D-PLCA Follower Node ID Time Randomization (Comment I-97)

IEEE 802.3da - September 2025 Interim – Minneapolis, MN

Fig 148-8 – D-PLCA Control State Diagram (pg 82)

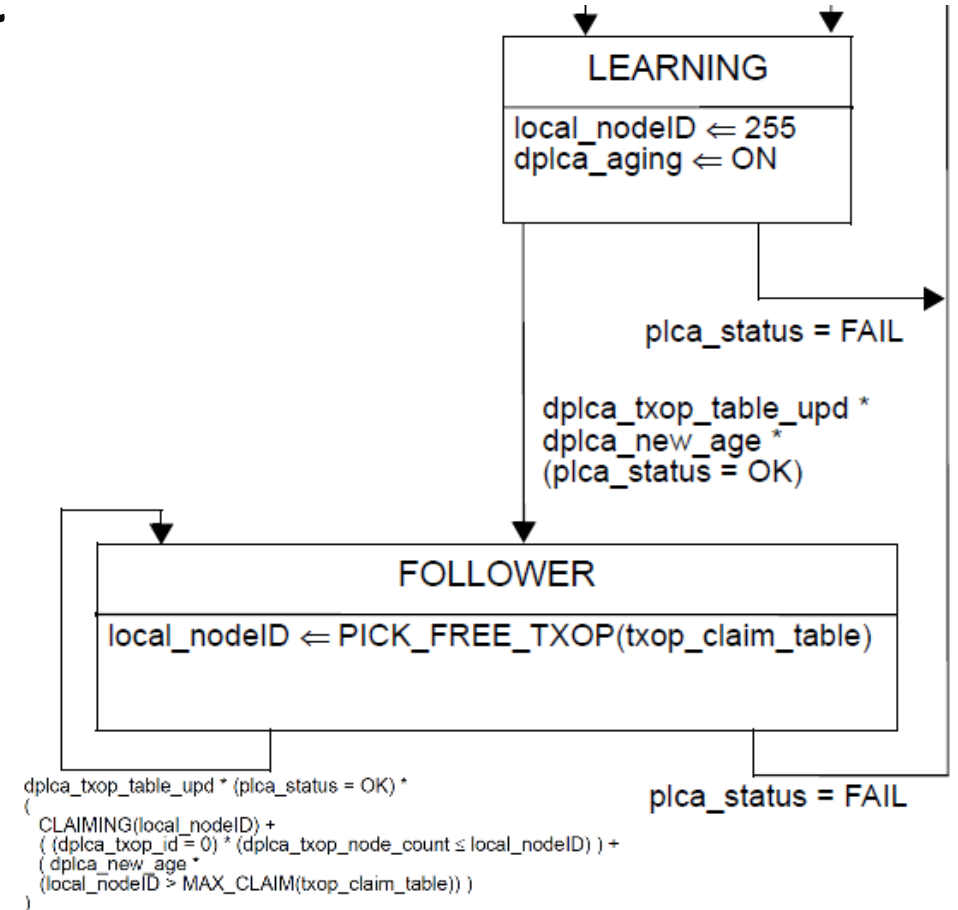
- **When Follower nodes first detect a BEACON, they enter the LEARNING state synchronously. They then select the same lowest claimed TO.**
 - The first node to successfully transmit a packet in the TO, wins the claim
 - But – multiple nodes *may* attempt to transmit in the same TO
 - Collisions are expected during start-up and convergence of the D-PLCA algorithm
 - Probability of collisions depends on transmit traffic patterns
- **Consider a segment of identical devices (same hardware, firmware, etc.) yielding identical behavior.**
 - If MPoE is used, they all will get powered-up simultaneously
 - The identical behavior will result in simultaneous transmission resulting in significant collisions and packet loss

Simulation of Worst Case with Proposed Change

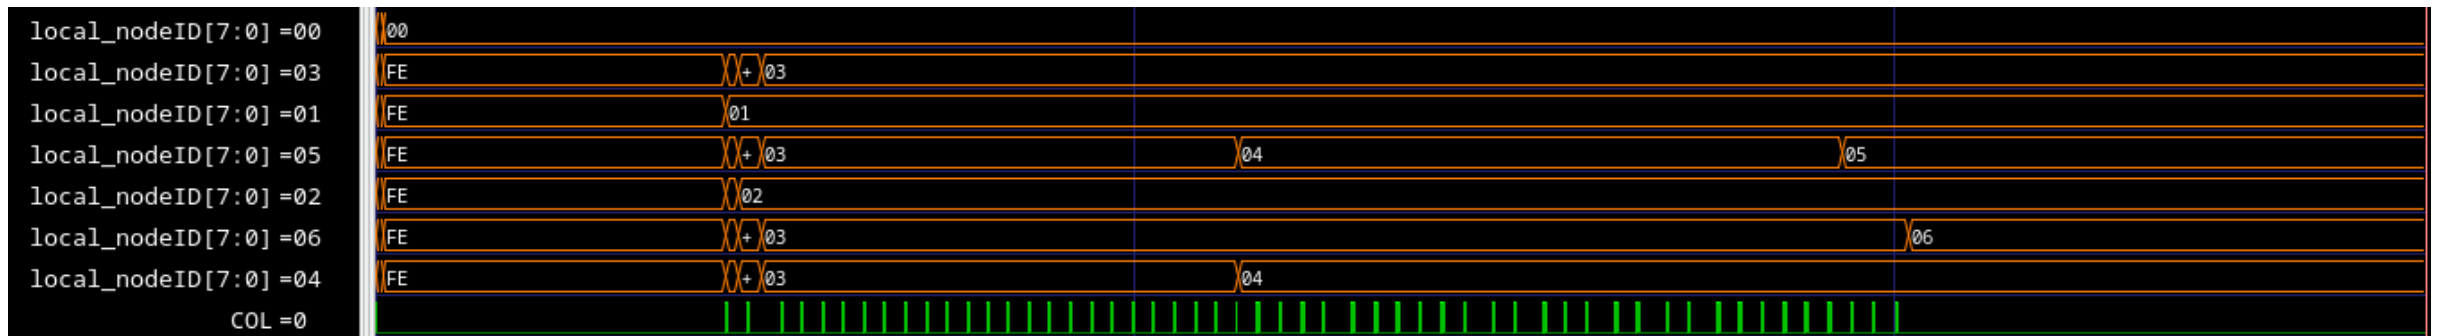
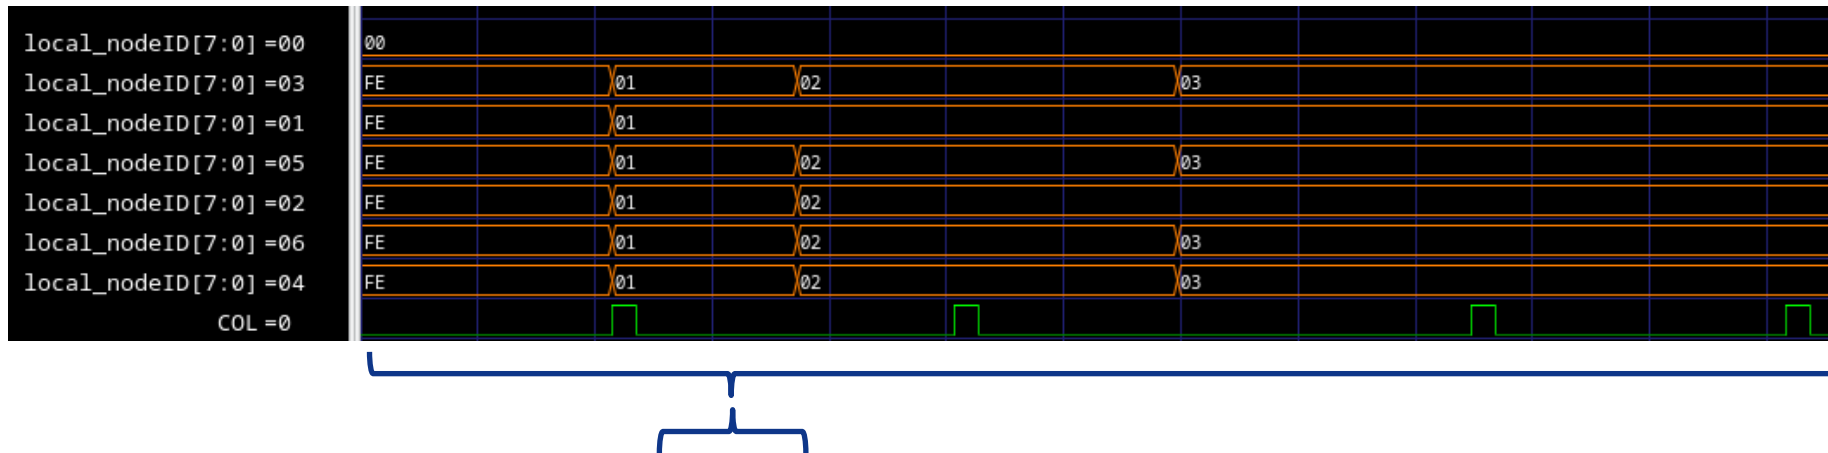
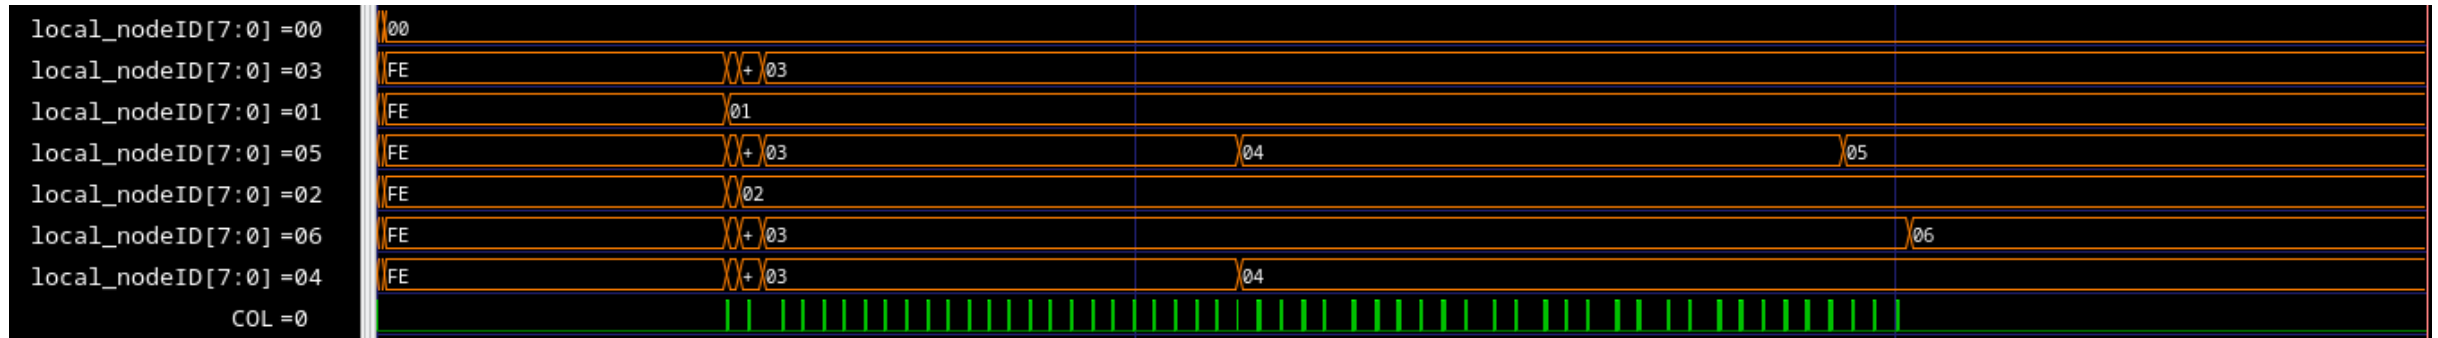
- Plot below illustrated the convergence of six Follower D-PLCA nodes on start-up.
- At reception of the first BEACON, the Follower nodes enter the LEARNING state and listen.
- Upon entering the FOLLOWER state for the first time all nodes select '1' which one successfully transmits and claims
- Remaining nodes then select TO '2' of which one successfully transmits and claims
- Remaining nodes then all select TO '3', and so on...

- **Simulation Results with proposed delay in picking free TO ID**
 - 0 collisions (compare to 78 without the change)
 - 4 excessive deferral errors (compare to 0 before the change)

Fig 148-8 Changes

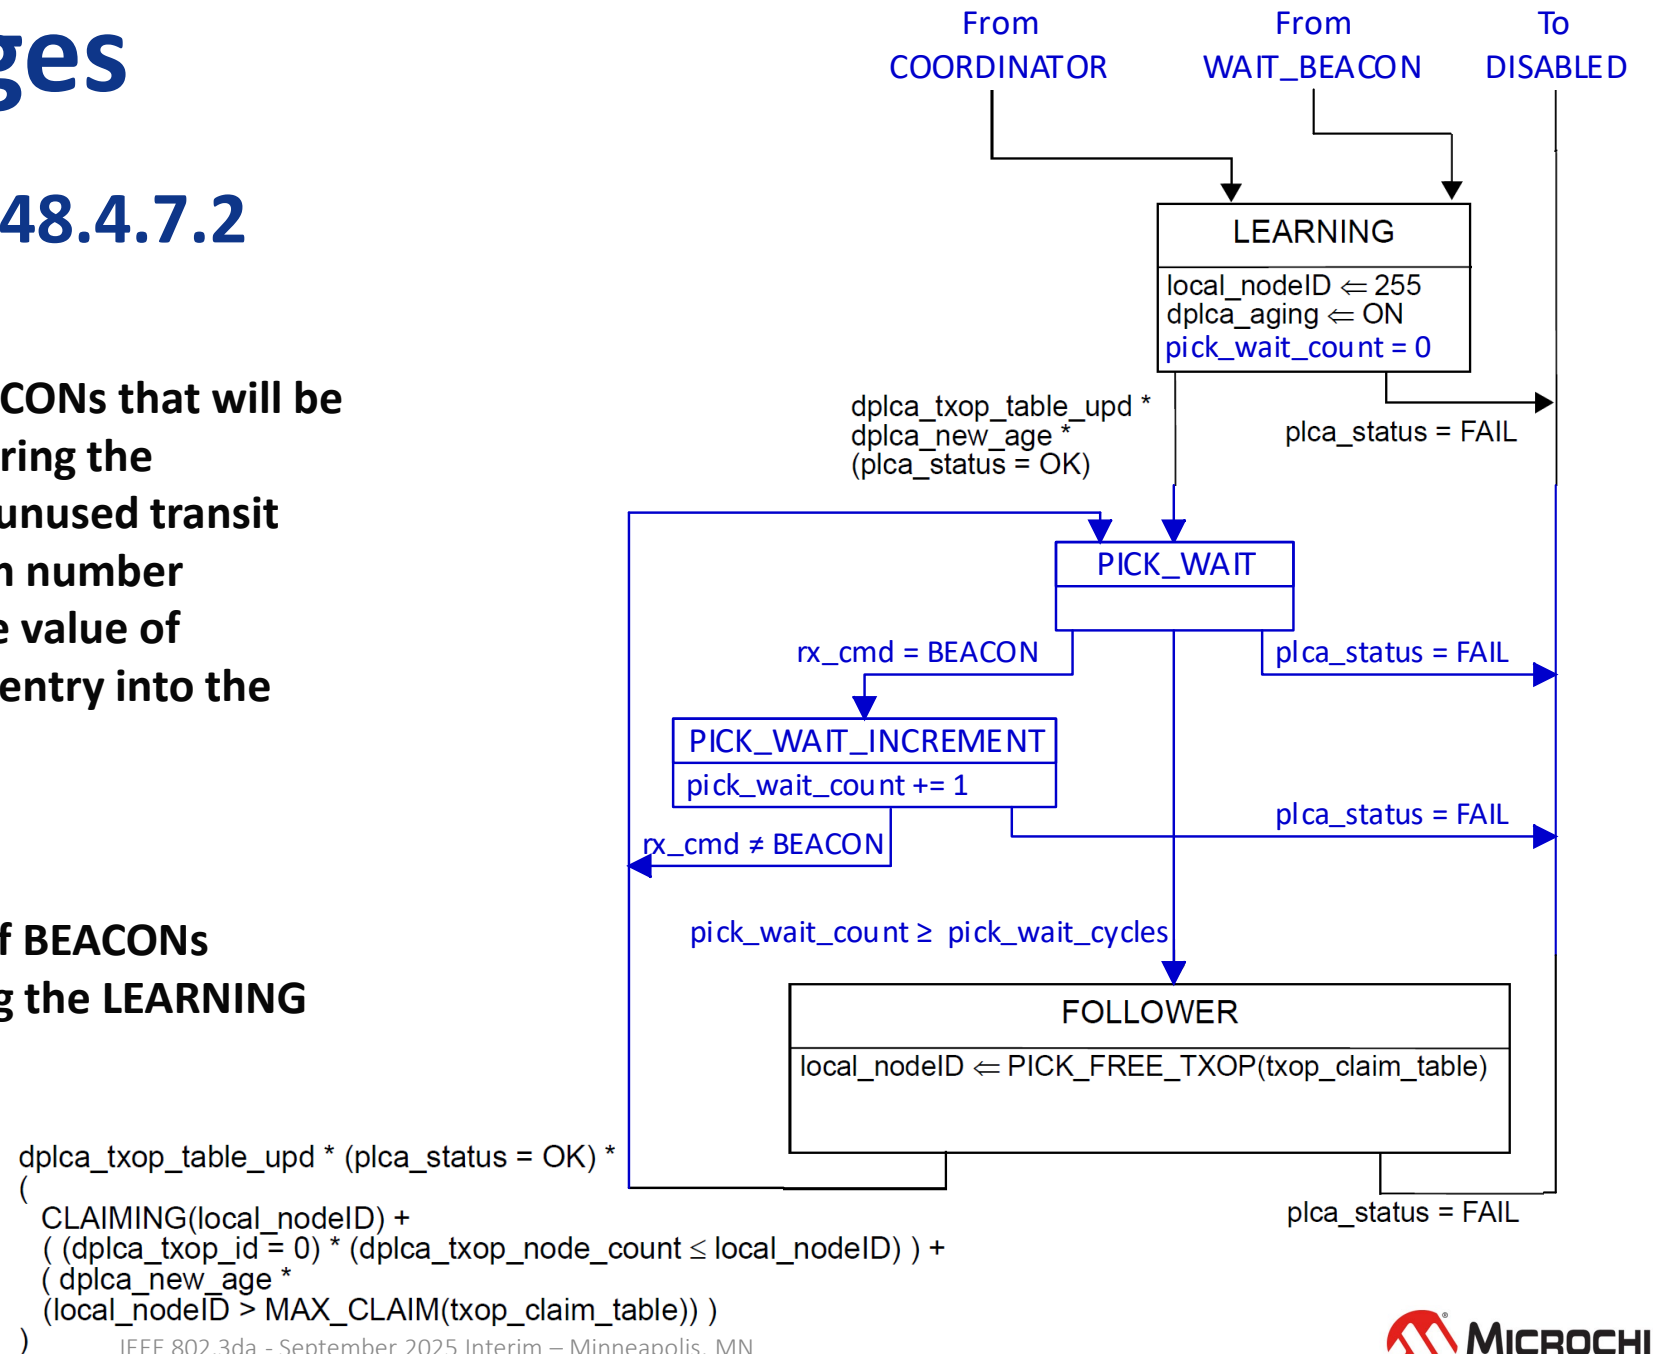
- **The solution proposed is to allow for a random number of PLCA cycles to occur before selecting the lowest unclaimed TO from the claim table.**
 - Nodes that wait less will have more cycles in which to transmit and claim the TO before other nodes that wait longer to pick a TO.
 - Nodes waiting longer will pick a different TO if the earlier node transmits & claims

New D-PLCA Variables 148.4.7.2

- pick_wait_cycles**

This variable is the number of BEACONS that will be received (PLCA cycles) before entering the FOLLOWER state and selecting an unused transit opportunity. The value is a random number selected from the range of 0 to the value of aging_cycles divided by two upon entry into the LEARNING and FOLLOWER states.

- pick_wait_count**

This variable counts the number of BEACONS received (PLCA cycles) since exiting the LEARNING state
